WESTLAKE PLANNING COMMISSION
STAFF REPORT
5/28/26

Faraj Plaza development plan, 27210 Center Ridge Rd., PP#21330015, Ward 4, *tabled 3/2/26, 4/6/26, 5/11/26*

Development Plan

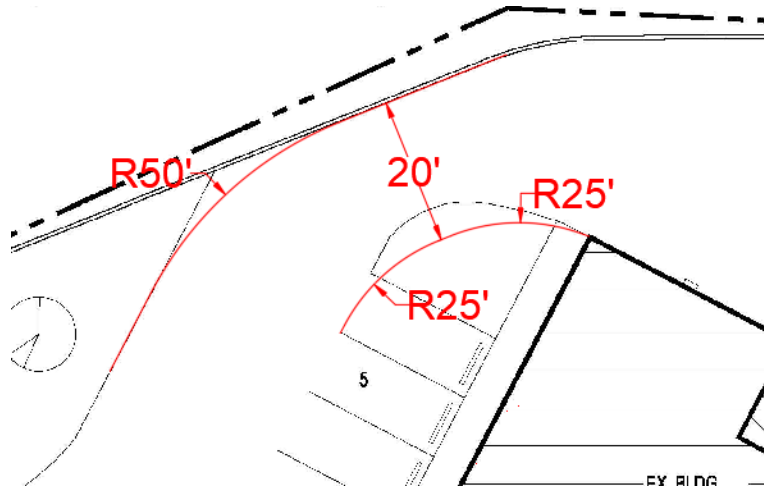
- The ***proposed*** building size remains the same ***from the prior submittal*** – a 2,373 SF addition to the existing 2,367 SF structure, for a total of 4,740 square feet.

- The building façade design is unchanged from the concept plan, with some material changes detailed in Part IV below. ***A material sample board has been provided providing the needed clarification.***

- Driveway aprons were reduced, with additional landscaping added where pavement was removed and in the area behind the building.
- Twenty-four parking spaces are shown (A-103); the spaces previously located at the northwest corner of the building were removed to address the inadequate 17.3-foot backing-up distance, and the revised layout now meets the required 24-foot maneuvering lane and functions properly. ***However, the Fire Department has previously required a redesign of site circulation to provide the required fire-lane access to the rear of the building and it does not appear that this has been addressed. This was previously noted in Part III and after discussing with Assistant Fire Chief Freeman, it is still required. A condition of approval is recommended to address it. The redesign will eliminate one parking space.***
